APPLICATION NUMBER 77-D-025

STAFF REPORT

Applicant: Albert J. Dwoskin, Trustee

Requested Zoning: R-12.5

PROJECT	GENERALIZED DEVELOPMENT PLAN
LOCATION	DRANESVILLE ESTATES
OWNER	DRANESVILLE ESTATES
DATE	10/15/77
BY	[Signature]

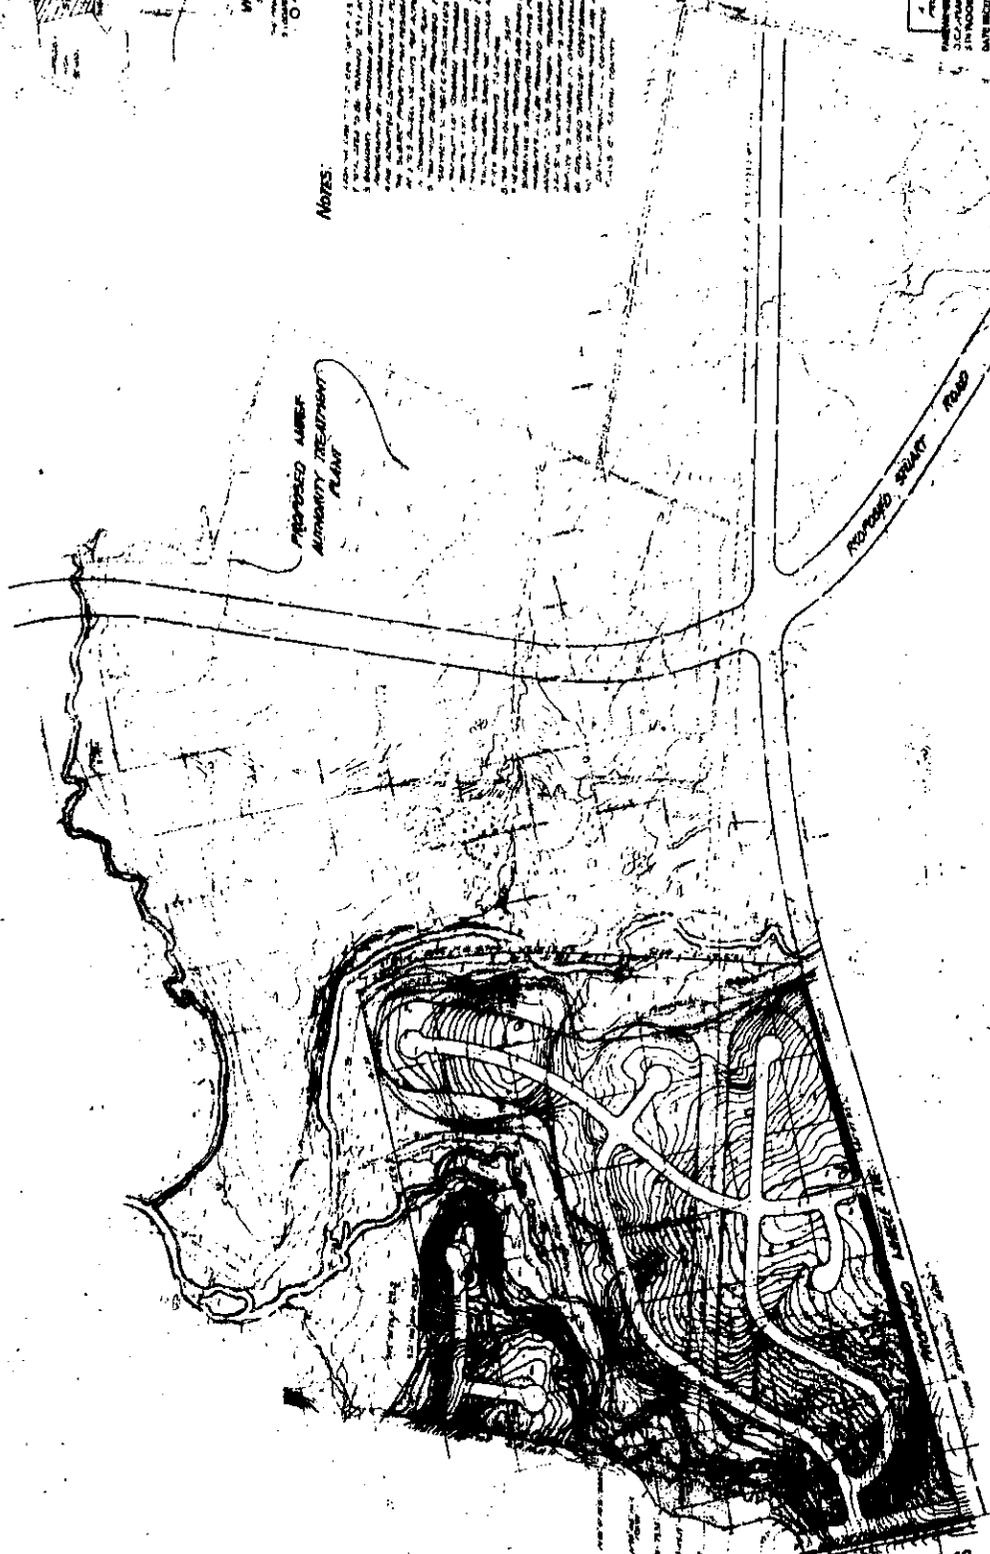
The staff offers the following comments to be considered with the final design. They are as follows:

1. Lot line placement should take advantage of the large potential for pleasant views.
2. As many eastern red cedar trees as possible should be preserved because they provide a unique landscaping amenity.
3. All monarch trees should be preserved.
4. Lot line and dwelling placement should reflect all natural drainage patterns on the site. Future wet basement and soggy backyard problems can be alleviated by placing units away from the natural drainageways and springs.
5. Due to the moderate to high shrink-swell capacities of Iredell-Mecklenburg, Montalto and Rock Land soil types, all footings should be placed on the hard bedrock to alleviate potential foundation damage.
6. Minor open space changes are recommended as shown on the accompanying map to avoid clearing steep slopes and/or high quality stream valley vegetation.

7. The southeastern cul-de-sac should swing to the south to correspond more closely with the topography. Similarly, the northwestern cul-de-sac should be realigned as shown on the accompanying map to correspond better with the existing topography.
8. Reverse frontage should be provided for all lots along Dranesville Road and the proposed Wiehle Avenue.
9. Rights-of-way for the improved Dranesville Road and the proposed Wiehle Avenue appear to be provided for adequately by the development plan; these rights-of-way should be dedicated by the owner/applicant.

The staff recommends, should the Board of Supervisors intend to amend the Zoning Ordinance as the applicant has requested, that the submitted development plan be proffered by the owner/applicant and accepted by the Board, and further that the following changes/improvements to the development plan be similarly proffered and accepted:

- ° On Dranesville Road, Route #228, dedicate right-of-way to 45 feet from center line, construct road widening to 12 feet from center line plus a standard shoulder, and construct a 150-foot long, 12-foot wide deceleration/right-turn lane for the site entrance.

- ° For proposed Wiehle Avenue dedicate right-of-way sufficient, in conjunction with the right-of-way to be dedicated from the property to the south, for a right-of-way totalling 90 feet in width. Dedicate additional right-of-way at the Dranesville Road/Wiehle Avenue intersection to accommodate a high level channelized design, viz, a free-flow right-turn lane.

- ° Provide reverse frontage for all lots along Dranesville Road and proposed Wiehle Avenue.
- ° In the subdivision plat for this property, provide as feasible for items 1 through 7 of the Design Considerations section of this report.

REZONING APPLICATION
77-D-025

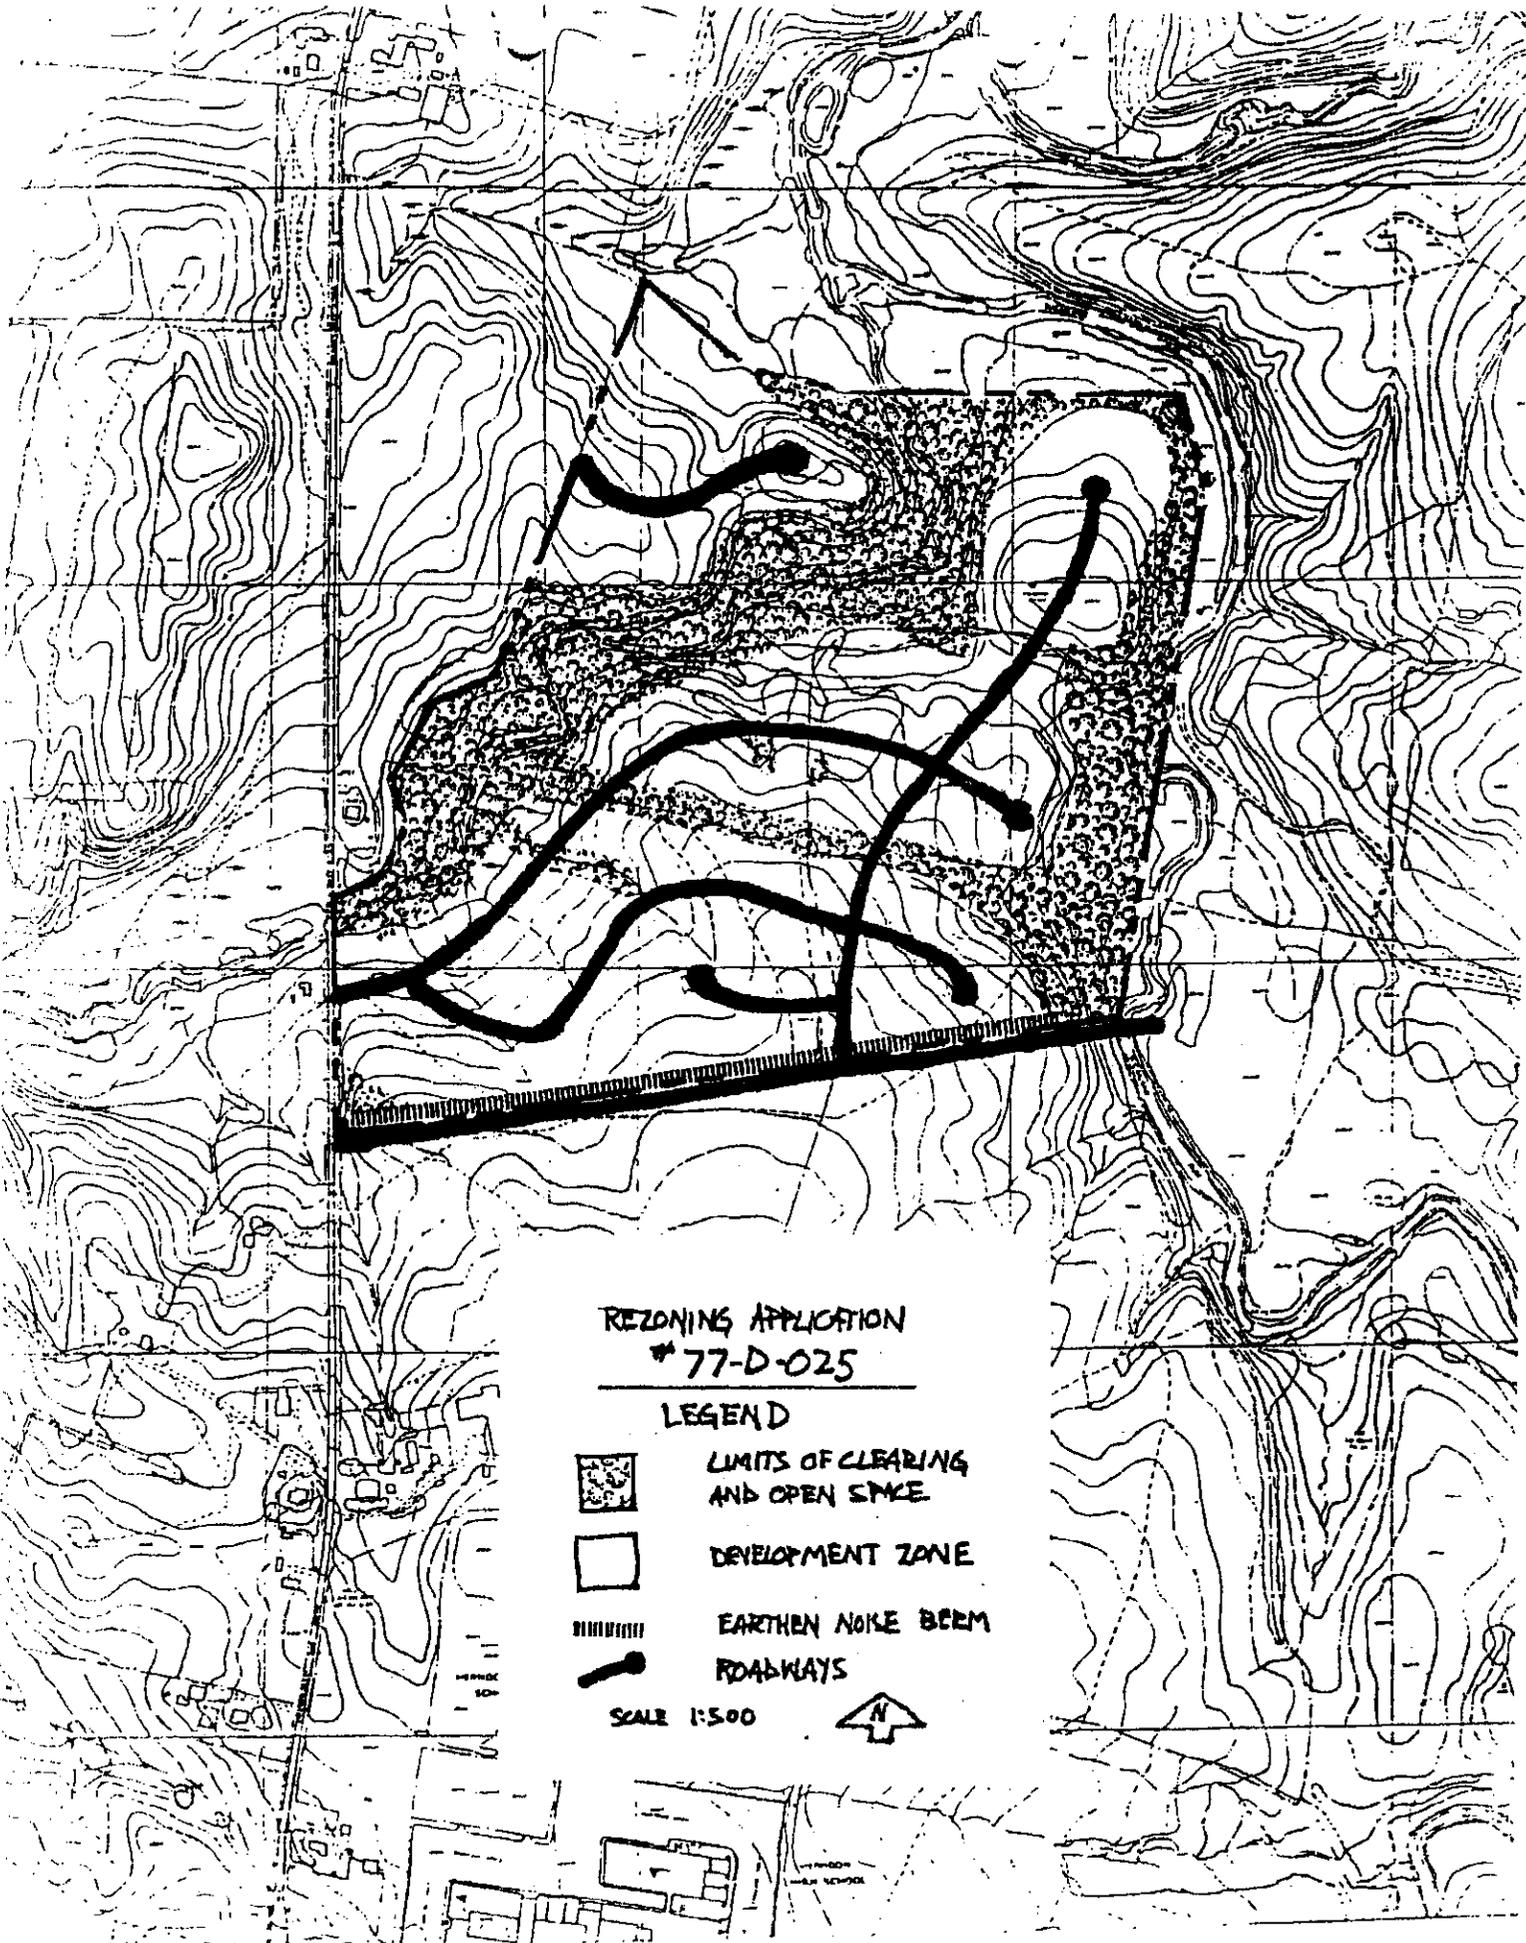
Iredell-Mecklenburg silt loam and Montalto stoney silt loam are shrink-swell soils located in the uplands. All footings should be placed on the hard diabase bedrock in order to limit the possible shrinkage-swelling damage, otherwise, voids are left under foundations when the soils dry out and shrink, causing settling and hence splitting, cracking or warping of the foundation. In many cases, blasting may be necessary to secure footings for houses and utilities requiring a substantial developmental cost increase. Water seepage into basements may occur as the underlying diabase is very hard and impermeable causing water to run horizontally with the dip and strike. The danger of land slippage is minimal due to the relative flatness of the topography and cohesiveness of the soils.
